**Proposal: 1 no detached four bedroom house.**

**Site: Land adjacent to 7 Central Drive, Elmer, Middleton, PO22 7TT.**

**M/105/18/PL**

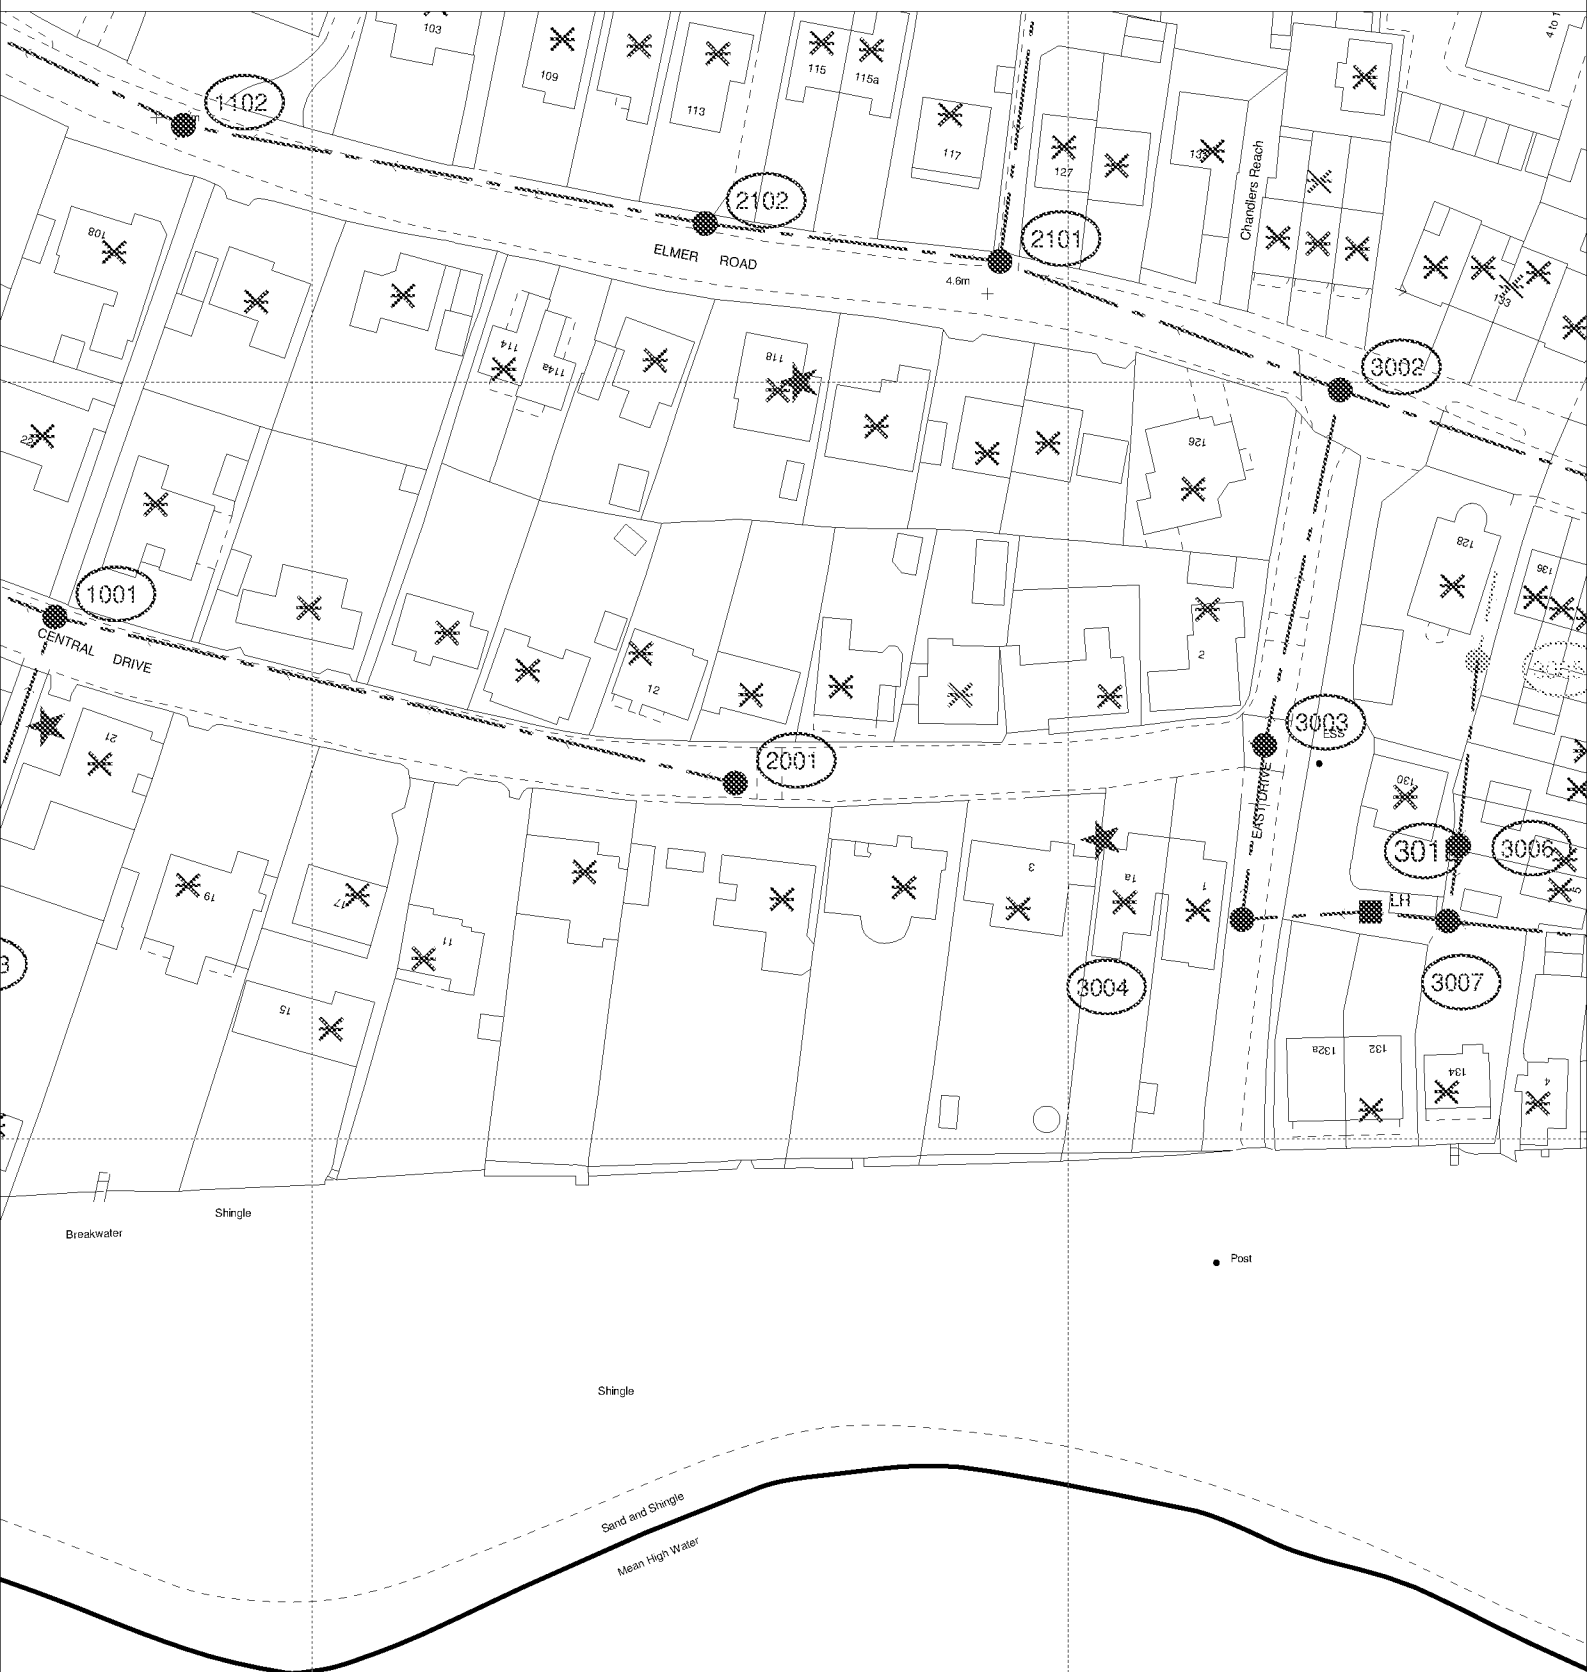
Due to surface water inundation issues in the Lidsey Catchment "The applicant is advised to adopt, where appropriate, the measures in the table "Practical measures to reduce the potential impacts of development".

Developer should look to protect the public sewerage system from inundation and infiltration, which contribute to flooding in unfavourable conditions.
